December 12, 2024

RE: Comments on the Millbrae and Burlingame Shoreline Resilience Project (MBSRP)
Fall 2024 Update Alternatives

Appendix 1: Alternatives A, B and C Footprints

San Francisco Airport boundary (dark blue) from the California State Geoportal¹.

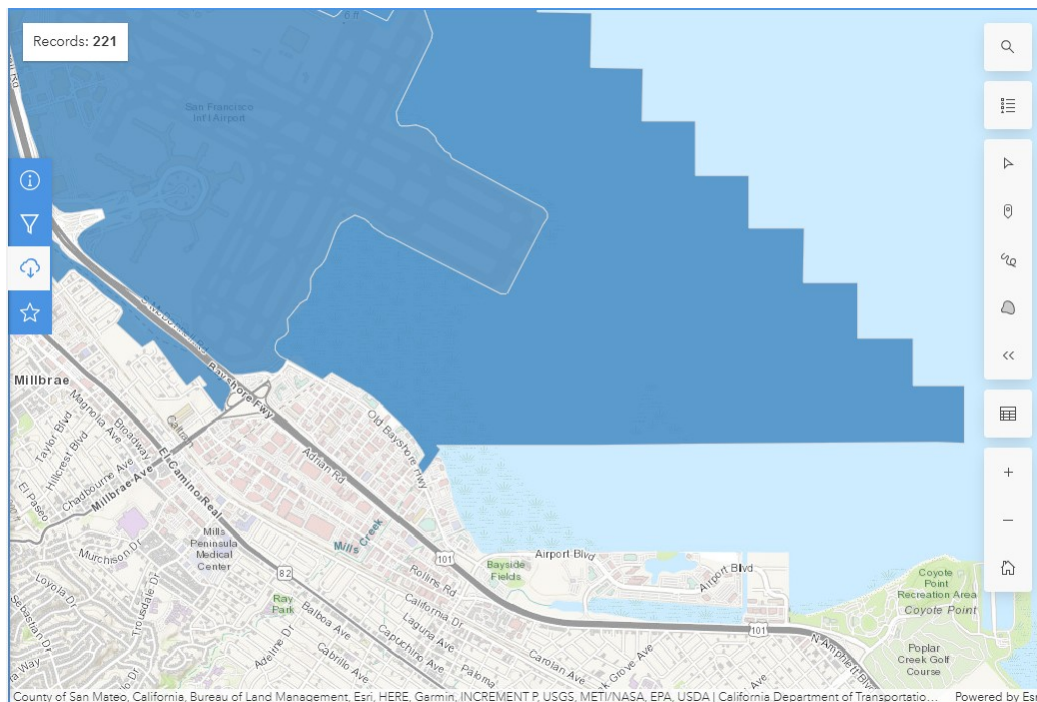
The section of shoreline from Highline Canal to Mills Creek is directly adjacent to the property boundary of San Francisco International Airport (SFO) as shown in the graphic below. It appears that the outboard footprint of all three new alternatives would encroach on airport property within the Bay. For the previous Offshore Barrier/Lagoon Alternative, correspondence from the San Francisco City Attorney indicated that authorization for construction of that alternative on airport property would not be granted.

Will SFO give OneShoreline permission to construct the Project on their property for any of the three new alternatives? This critical question must be answered before the alternatives analysis and selection process proceeds further. If encroachment on SFO property is not an option, the Project plans for the shoreline reaches from Highline Canal to Mills Creek will need to be reconsidered.
